# ISO/IEC JTC 1/SC 25/WG 3 N 807

**DOC TYPE:** Liaison report  
**TITLE:** Liaison report from ISO/IEC/JTC 1/SC 25/WG 3 to IEEE 802.3 on Update on cabling issues to support IEEE P802.3at PoEP  
**SOURCE:** ISO/IEC JTC 1/SC 25/WG 3 (Berlin 48A)  
**PROJECT:** 25.03.xx.xx: Generic cabling for xx  
**STATUS:** Liaison report developed at Berlin.  
**ACTION ID:** FYI  
**DUE DATE:** N/A  
**REQUESTED ACTION:** to IEEE 802.3 for consideration to WG 3 for information.  
**MEDIUM:** Def  
**No of Pages:** 7 (including cover)

## **Liaison report from ISO/IEC/JTC 1/SC 25/WG 3 to IEEE 802.3 on Update on cabling issues to support IEEE P802.3at PoEP**

To: IEEE 802.3  
From: ISO/IEC JTC 1/SC 25/WG 3  
41<sup>st</sup> Meeting of WG 3  
Berlin, Germany, 2006-09-19/21  
Date: 2006-09-25

**Figure 7 – Equipment and test interfaces**

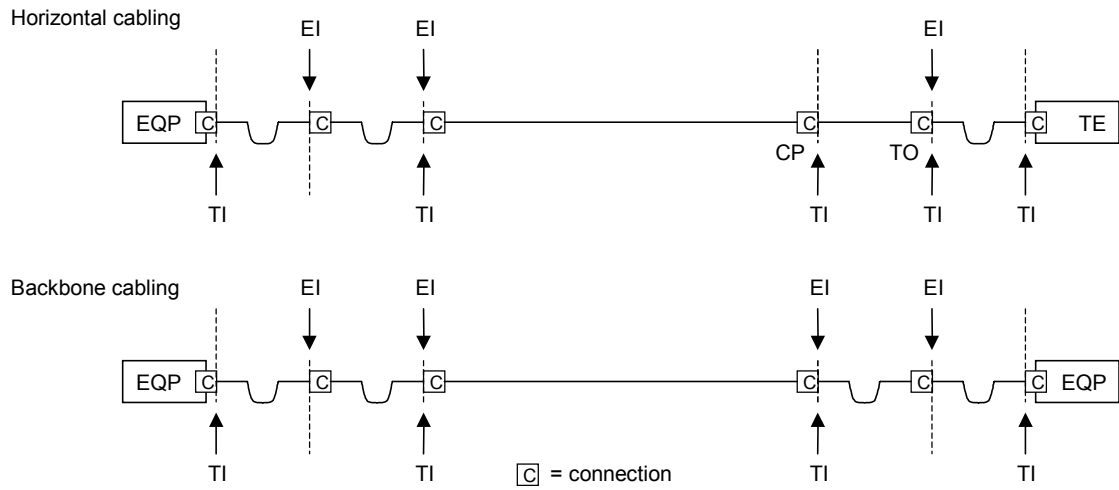
**IEEE 802.3 question 1:** The actual channel loop resistance is a topic of debate, and IEEE would appreciate some guidance for Medium Dependent Interface (MDI) to MDI links on what the loop resistance applies to and applicable operating conditions.

**SC 25/WG 3 response 1:** Please see ISO/IEC 11801 Ed2 channel definition and drawings (clause 3.1.15 and figure 7 are attached as Annex 1). Figure 7 shows where the channel exactly starts. Please also see Annex 2, MICE table, and note that MICE 1 is for the general commercial office environment. Class D 2002 DC loop resistance is 25  $\Omega$ , and Class D 1995 was specified at 40  $\Omega$  at 20 °C.
